# UNITED STATES PATENT AND TRADEMARK OFFICE

**Advisory Action  
Before the Filing of an Appeal Brief**

10/754,546

THE REPLY FILED 30 January 2006 FAILS TO PLACE THIS APPLICATION IN CONDITION FOR ALLOWANCE.

- Front View of Amorphous Semiconductor Silicon during Laser Crystallization

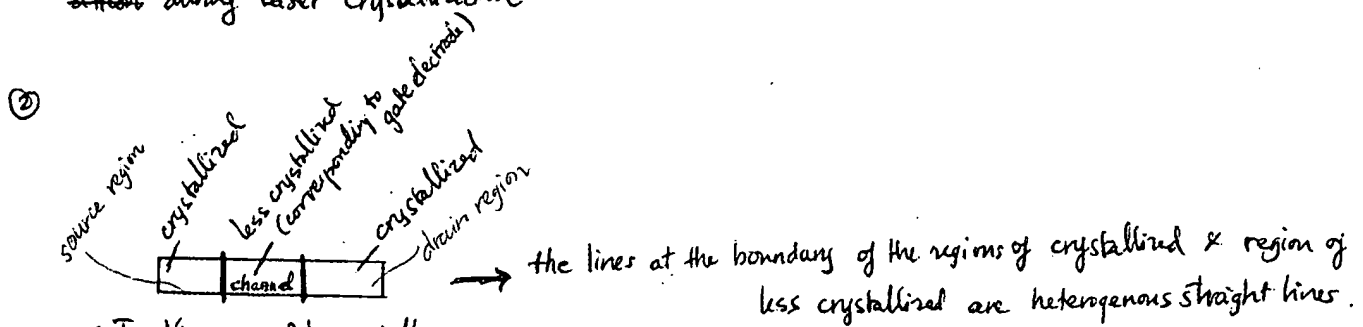
2. Examiner takes position as when forming channels (for thin film transistors) from the amorphous semiconductor layer, the gate electrode is used as a mask, and after laser crystallization, the heterogeneous straight lines inherently formed at the boundary of the regions of crystallized (source/drain regions) and region of less crystallized (channel), [see attachment provided by Examiner for the Advisory Action – paper No. 20060210]. Further, in the Remarks of the After Final Amendment, what applicant discusses/argues such as "heterogeneous straight lines, which have electrical properties, e.g. conductivity, that are different than other areas of the semiconductor, may be formed when a region of the semiconductor is subject to laser beam irradiation" is from the specification, not from the claims. Therefore, the discussion/argument regarding this feature would not be given any weight by the Examiner.
